ADDENDUM NUMBER TWO (2)

DATE: FEBRUARY 3, 2026
PROJECT: 06-141-25 BENNETT AUDITORIUM INTERIOR UPGRADES
(CURTAIN REPLACEMENT)
FROM: CHRISTINE WALCK, AIA, NCIDQ
CAMPUS FACILITIES SPECIALIST – USM
TO: ALL BIDDERS

24-022P
BENNETT
AUDITORIUM
INTERIOR
UPGRADES

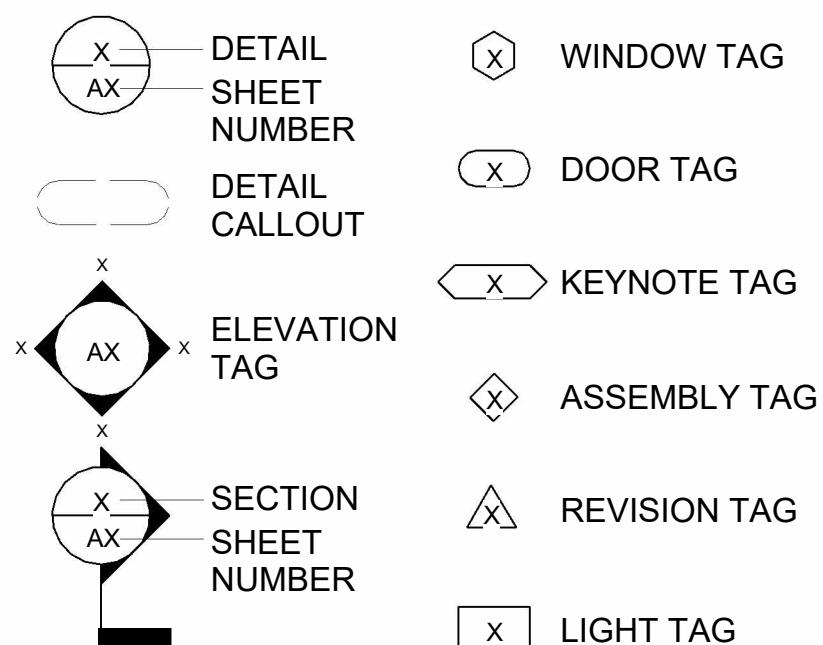
7. Is the color of the fabric a custom color/does it have a Pantone or Hex code if so?
 - a. A Pantone nor a Hex code is available. The color is best described as a soft gold tone similar to the picture below and best represented as specified (KM Fabrics, Imperial Prestige Wheat 1003. Note, final fabric selection will be approved by submittal.

CURTAIN ELEVATIONS

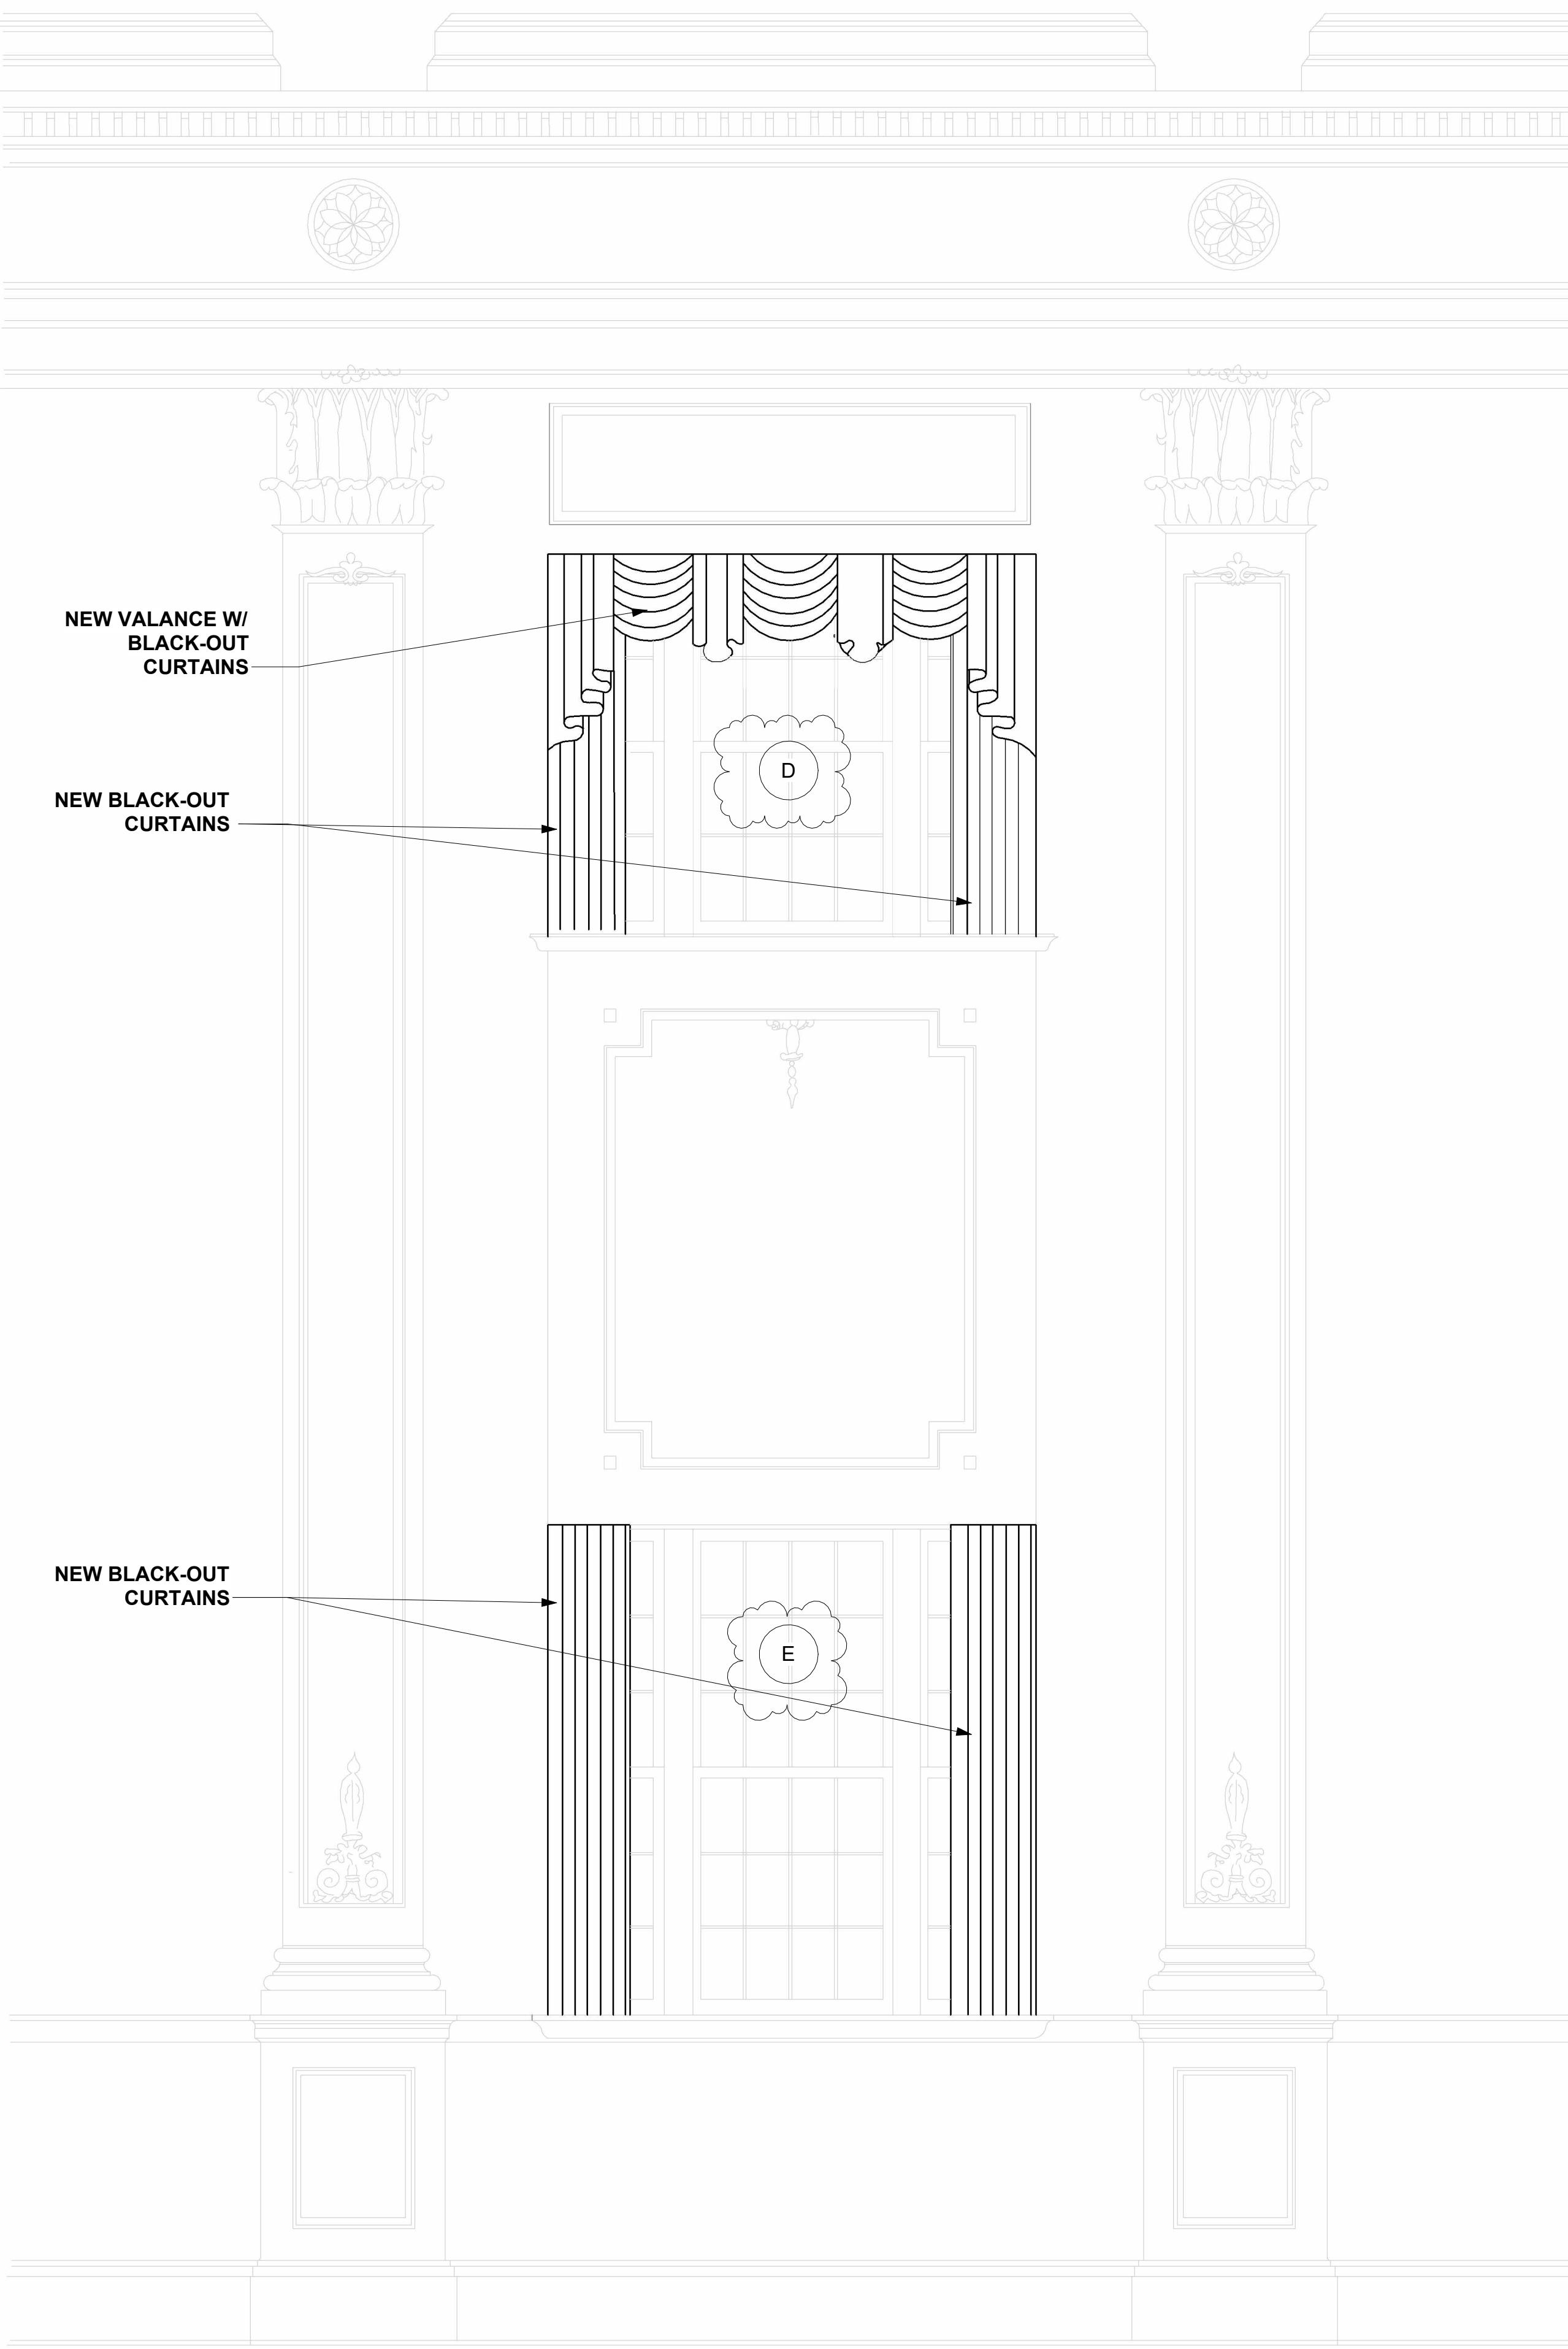
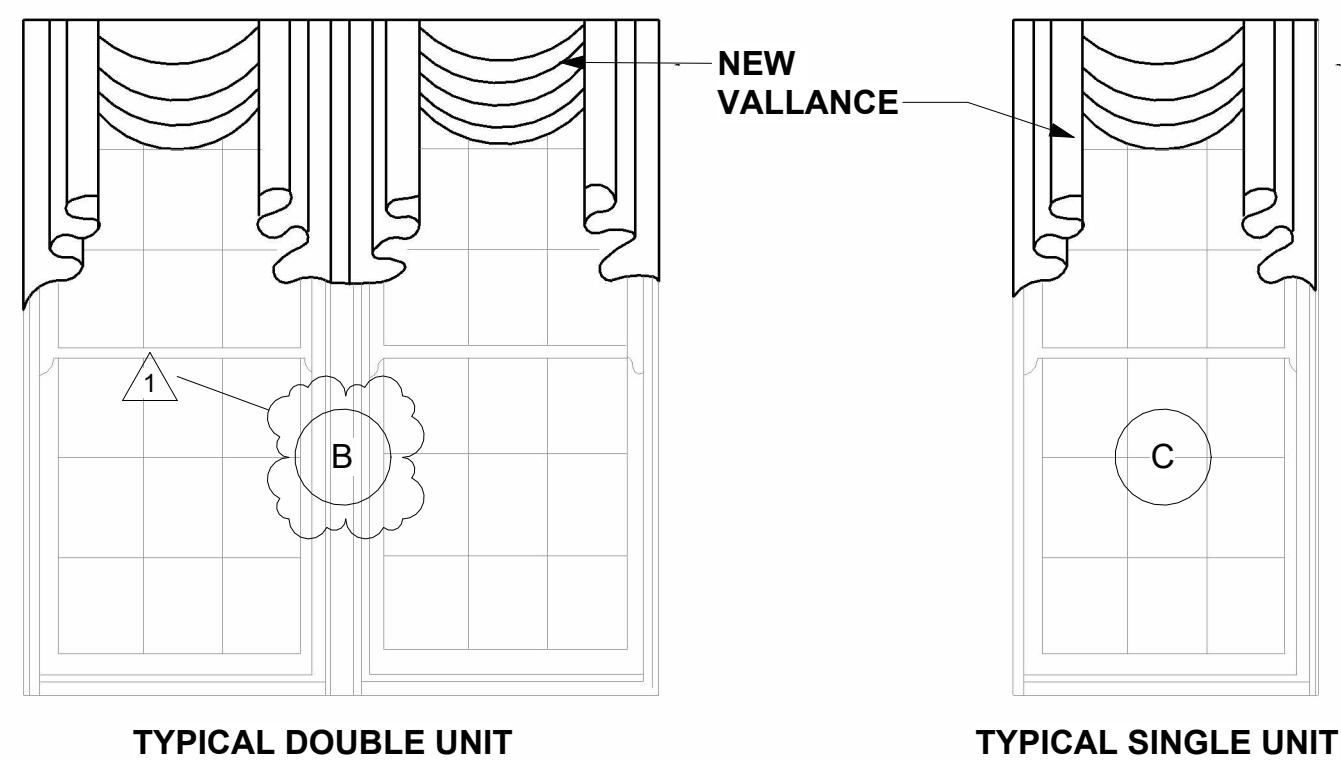
1. 01/16/2026:
A. DEPARTMENT DIRECTED: CARPET REPLACEMENT
SCOPE REMOVED FROM PROJECT.
B. OMISSION OF SHEET A102.
2. 02/03/2026:
A. ADDITION OF DRAPERY SCHEDULE.
B. CLARIFICATION OF MAIN ENTRY, BALCONY LEVEL
CURTAINS.
C. OMISSION OF REFERENCE PLAN 3/A100.

DRAPERY SCHEDULE				
WINDOW TAG	DIMENSIONS	DRAPERY	HARDWARE	REMARKS
A	6'-0"H X 2'-0"W	---	---	
B	7'-6"H X 6'-8"W	VALANCE	STRAIGHT TRACK SYSTEM	
C	7'-6"H X 3'-4"W	VALANCE	STRAIGHT TRACK SYSTEM	
D	6'-8"H X 8-0"W	VALANCE & BLACKOUT CURTAIN	CURTAIN TRACK SYSTEM RIGGED FOR BI-PARTING MANUAL ROPE DRAW OPERATION	
E	8'10"H X 7'-8"W	BLACKOUT CURTAIN	CURTAIN TRACK SYSTEM RIGGED FOR BI-PARTING MANUAL ROPE DRAW OPERATION	
F	4'-6"H X 7'-8"W	HALF BLACKOUT CURTAIN	CURTAIN TRACK SYSTEM RIGGED FOR BI-PARTING MANUAL ROPE DRAW OPERATION	
G	4'-8"H X 2'-0"W	---	---	
H	3'-4" X 3'-4"	---	---

- **TOP WINDOW CURTAINS (TYPE D, 20 PANELS)**
 1. PANELS MANUF. FROM 26OZ IFR VELOUR W LITEOUT LINING SEWN W 100% FULLNESS SEWN IN THROUGH BOX PLEATS. TOP FINISH TO BE STANDARD GROMMETS, JUTE & BITSNAPS. BOTTOM FINISH TO BE 5" HEM W INTERNAL CHAIN WEIGHT. COLOR TBD (SOFT GOLD HUE)

- **BOTTOM WINDOW CURTAINS (TYPE E, 16 PANELS)**
 1. PANELS MANUF FROM 26OZ IFR VELOUR W LITEOUT LINING SEWN W 100% FULLNESS SEWN IN THROUGH BOX PLEATS. TOP FINISH TO BE STANDARD GROMMETS, JUTE, & BITSNAPS. BOTTOM FINISH TO BE 5" HEM W INTERNAL CHAIN WEIGHT. COLOR TBD (SOFT GOLD HUE)

- **BOTTOM HALF WINDOW CURTAINS (TYPE F, 4 PANELS)**
 1. PANELS MANUF FROM 26 OZ IFR VELOUR W LITEOUT LINING SEWN WITH 100% FULLNESS SEWN IN THROUGH BOX PLEATS. TOP FINISH TO BE STANDARD GROMMETS, JUTE, BITSNAPS. BOTTOM FINISH TO BE 5" HEM WITH INTERNAL CHAIN WEIGHT. COLOR: TBD (SOFT GOLD HUE)

- **VALANCE CURTAIN (TYPE D, 10)**
 1. PANELS MANUF FROM 26OZ IFR VELOUR W LITEOUT LINING SEWN W 100% FULLNESS SEWN IN THROUGH BOX PLEATS. BOTTOM FINISH TO BE 5" HEM W INTERNAL CHAIN WEIGHT. COLOR: TBD (SOFT GOLD HUE)

- **TOP/BOTTOM WINDOW TRACKS (TYPE D,E,F, 1 EA)**
 1. BASIS OF DESIGN: CONSTRUCTED FROM H&H SPECIALTIES 200 SERIES CURTAIN TRACK SYSTEM RIGGED FOR BI-PARTING MANUAL ROPE DRAW OPERATION.

- **VALANCE CURTAIN (TYPE B,D, 16 PANELS)**
 1. PANELS MANUF FROM 26OZ IFR VELOUR W LITEOUT LINING SEWN W 100% FULLNESS SEWN IN THROUGH BOX PLEATS. BOTTOM FINISH TO BE 5" HEM W INTERNAL CHAIN WEIGHT. COLOR: TBD (SOFT GOLD HUE)
- **WINDOW CURTAIN (NONE)**
- **WINDOW TRACKS (TYPE B,D, 1 EA)**
 1. BASIS OF DESIGN: CONSTRUCTED FROM H&H SPECIALTIES 200 SERIES CTRACK SYSTEM.
